UNITED STATES PATENT AND TRADEMARK OFFICE

APPLICATION NO.	FILING DATE	FIRST NAMED INVENTOR	ATTORNEY DOCKET NO.	CONFIRMATION NO.
10/801,524	03/12/2004	Gary Wayne Hogue	4705-2	3181

Office Action Summary

DETAILED ACTION

FIG. 1

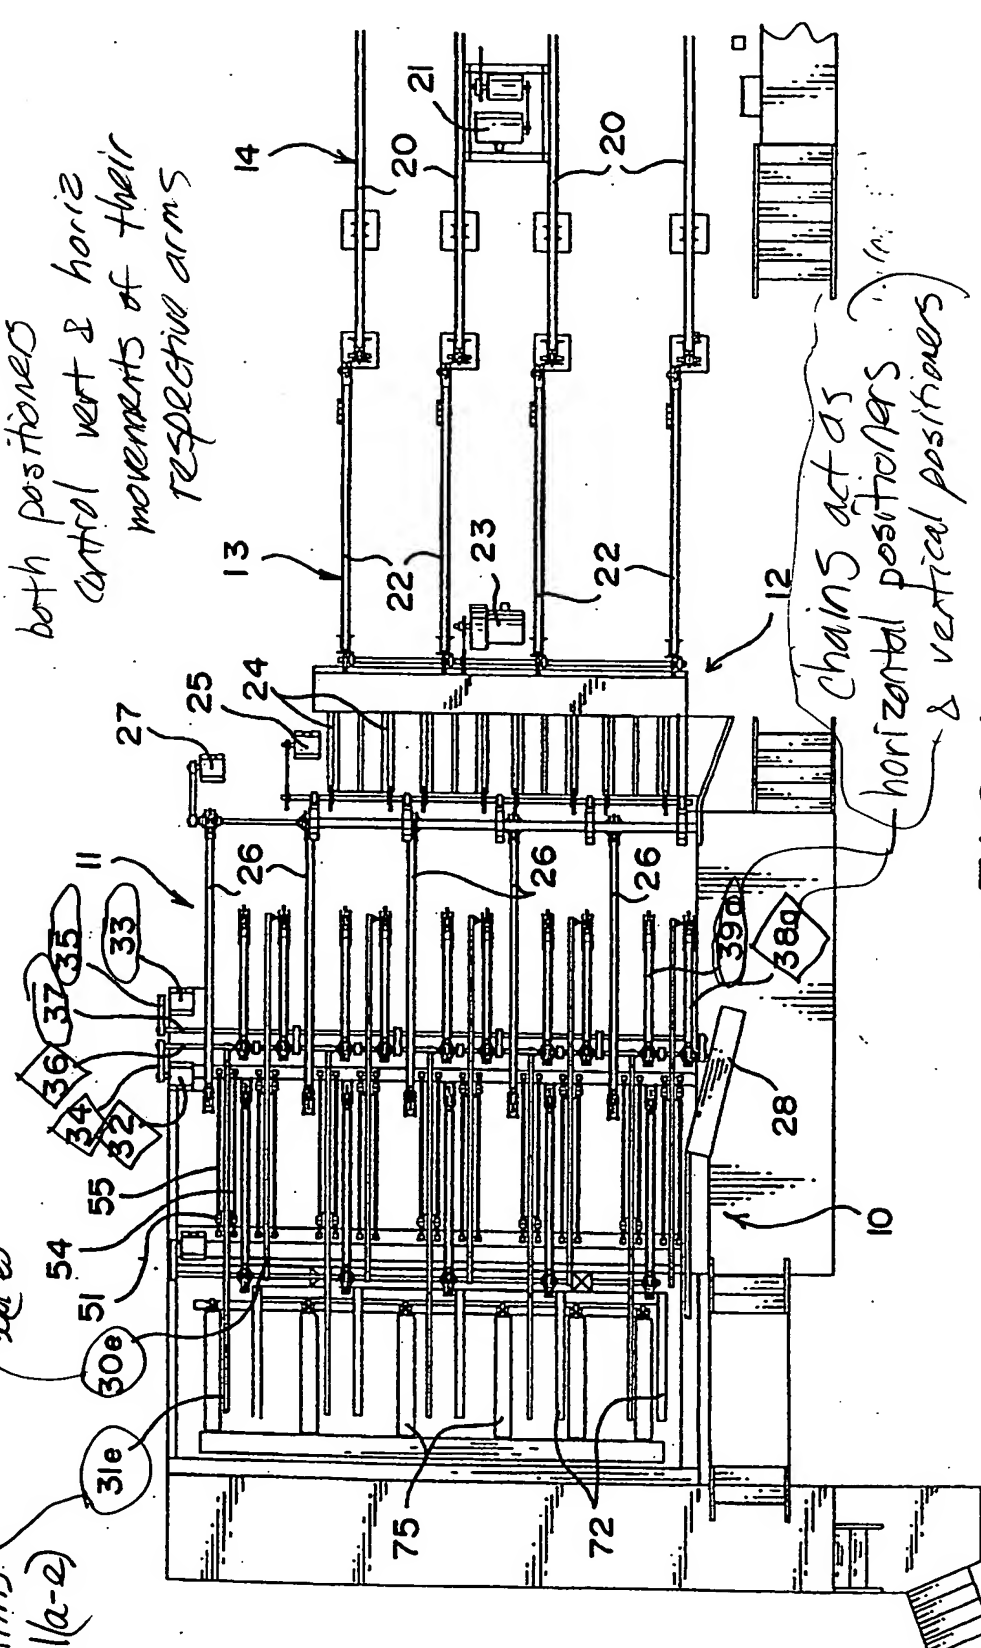
See the attached marked up drawing figure 1 of Vande Linde depicting the claimed features.

1st elect.-controlled positioner = 32, 34, 36, 38
 2nd elect.-controlled positioner = 33, 35, 37, 39
 both positioners
 control vert & horiz
 movements of their
 respective arms

1st Set
 Stacking
 Arms
 30(a-e)
 54
 51
 30e
 31e
 2nd Set
 Stacking
 Arms
 31(a-e)

controls speed, but does not change speeds
 electronic control system = see spec COL 5, line 45
 and COL 7, line 21

RE claims 7-8
 1st positioners are engaged & disengaged by
 2nd positioners

(claim 2) provides hard-coupled system to generate horiz. movement
 of stacking arms as claimed
